Docket Item #8
BAR CASE # 2007-0002

BAR Meeting
October 3, 2007

ISSUE: Addition and alterations
APPLICANT: Amy & Brien Biondi
LOCATION: 833 South Lee Street
ZONE: RM/Residential

The applicant is requesting approval of a Certificate of Appropriateness for a new third story and a new side addition for the end unit residential rowhouse at 833 South Lee Street.

Figure 1: Proposed east elevation

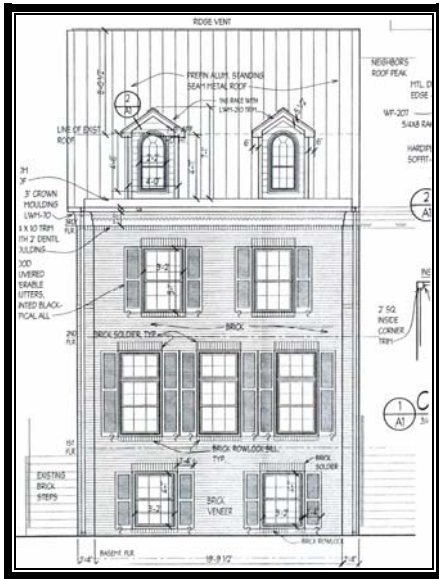
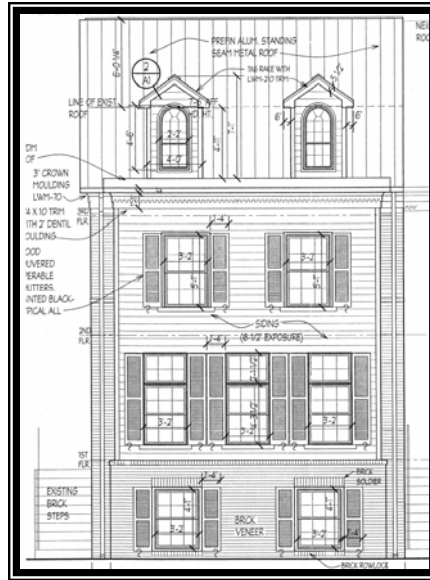
Staff is not as convinced that the revision to the eastern addition is a success. The only alteration made was the change in material. While the brick may be an improvement when viewing the front (east) elevation, as it helps to tie the addition to the existing house, the resultant two-and-a-half stories of unrelieved brick wall on the south side of the addition is not an improvement. The wall should be broken up in some way that is in character with the simple Colonial Revival style of the house. Given the extensive use of brick in the additions, staff would feel more comfortable if given an opportunity to review and approve the brick. Staff notes that the relationship of the roofline of the east side addition and the main block and the dormers that concerned the Board remains unresolved. Therefore, staff recommends that the application be deferred yet one more time to continue to work on refining the design of the east side addition.

The only revision to this addition is the elimination of the lap siding in favor of brick.

Figure 5: Proposed west elevation

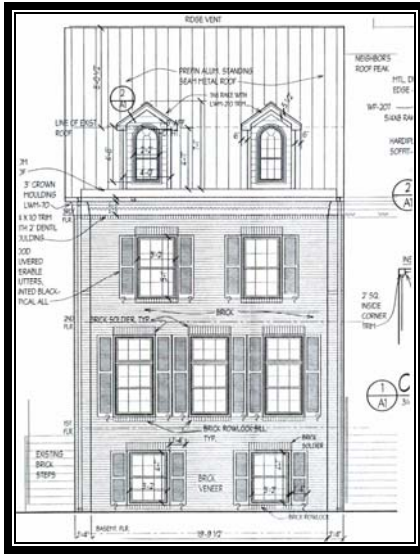
Although the new roof arrangement of the third story addition results in a slightly higher roof peak, staff believes it does provide a much more harmonious appearance on the south elevation facing Green Street. The visual impact of the shed dormer is significantly reduced. The fenestration is more balanced and quiet. While the height has been raised, it will be only 2' higher than the peak of the roof at the neighboring house at 720 South Lee Street and will be relatively less massive than that roof.

The shed dormer on the west slope of the new front gable is smaller than in the previous iteration. It no longer originates at the peak of the gable, but is set into the slope 2' down from the peak. It is recessed back from the south edge of the building facing Green Street by 1'. This southern side facing Green Street will be clad in smooth finish Hardiplank siding, with nails concealed, and painted white. Where there had been a window in this side, there is now none. The west face of the new third floor shed dormer will also be clad in smooth-finish Hardiplank, with concealed nails, and painted white. There will be one six-over-six double-hung, double-glazed wood window, with simulated divided lights, by Pella. The window will have shutters.
